TECHNICAL BULLETIN

MODEL/DERIVATIVE:
Mini

Bulletin N°: 0025
CDS. ref: X8420bu
Issue: 1
Date: 2.06.99

PROBLEM:
ENGINE STEADY BUSHES WEAK - MODIFICATION

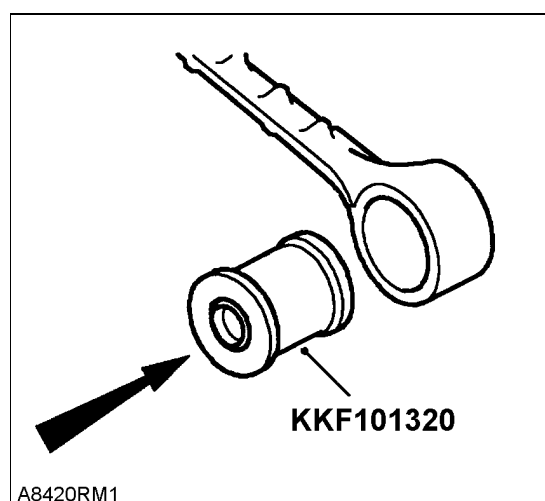
Knock from engine compartment when clutch is engaged or throttle is applied.

CAUSE:
Upper engine steady bushes not capable of withstanding increased engine torque*. Therefore bushes have become weak or worn prematurely.

*** Current engines i.e. 1298cc MPI produce considerably more torque than earlier 998 cc carb type engines for which the original bushes were designed.**

ACTION:
To increase upper engine steady bush durability, replace the 2 upper rubber bushes for single bush part number KKF101320.

NOTE: This bush cannot be used on the lower tie bar. This is due to the fixing bolt being a different size to the upper.

- 1. Remove upper engine steady from vehicle and remove worn bushes and spacer tube from steady.**
- 2. Press new single bush KKF101320 complete with bonded internal spacer tube into engine steady. To assist fitment, the new single bush assembly can be pushed into steady with the help of a vice and a suitable spacing tube such as a socket, (there is no special tool available for this purpose).**
- 3. Refit upper engine steady to vehicle.**
